CUSTOMER NOTIFICATION

SUD-DT-03-0325-1-E (1/5)
July 31, 2003
Yoshiro Harada, Senior System Integrator Microcomputer Group 2nd Solutions Division Solutions Operations Unit NEC Electronics Corporation

# IE-178098-NS-EM1 (Control Code: A, B, C, D)

## Operating Precautions

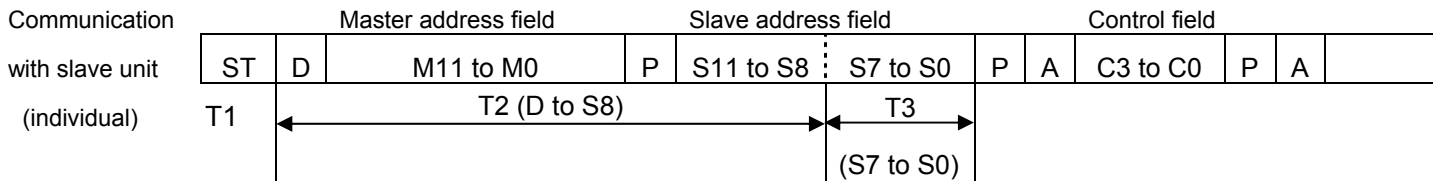
- (1) When the local unit issues a broadcasting mastership request while the other unit is performing an individual communication with another slave unit in the local unit group, the local unit may mistakenly receive the individual communication as a broadcasting communication (ALLTRANS = 1).

This error occurs only when the local unit issues a broadcasting mastership request during the period between the broadcasting field and bit 8 of the slave address field in individual communication between slave units (T2 in the figure below).

- (2) When the local unit issues a broadcasting mastership request while receiving an individual communication, ACK is not returned in the slave address field and no start interrupt is generated. However, ACK is returned and a start interrupt is generated if the local unit issues a broadcasting mastership request during individual communication with a unit in the same group and whose lower address is FFH.

This error occurs only when the local unit issues a broadcasting mastership request during the

period from bits 7 to 0 in the slave address field (T3 in the figure below).

- (3) After the broadcasting mastership request is issued, if the local unit lost in arbitration and is specified as a slave, no error interrupt is generated even when a parity error occurs in the data field.

- (1) • Disable slave reception when the broadcasting mastership request is issued (BCR = #E0H)
- If a slave request is detected (SLVRQ = 1) in the start interrupt servicing after a broadcasting mastership request is issued, clear the broadcasting mastership request flag. At this time, the subsequent data can be made invalid if the broadcasting communication flag (ALLTRANS) has been cleared to 0.

- (2) There is no software workaround on the local unit side.

At that time, a communication error occurs on the master side by NACK reception. A timing error occurs in the local unit because the master stops communication. Therefore, it is possible to avoid this restriction if the master side performs re-transmission processing.

- (3) In the reception complete interrupt servicing, confirm a match between the received telegraph length data (DLR) and the number of data actually received, by checking the reception interrupt count (INTE1) generated in the period from reception start to end.

These bugs have been corrected in control code D or later.
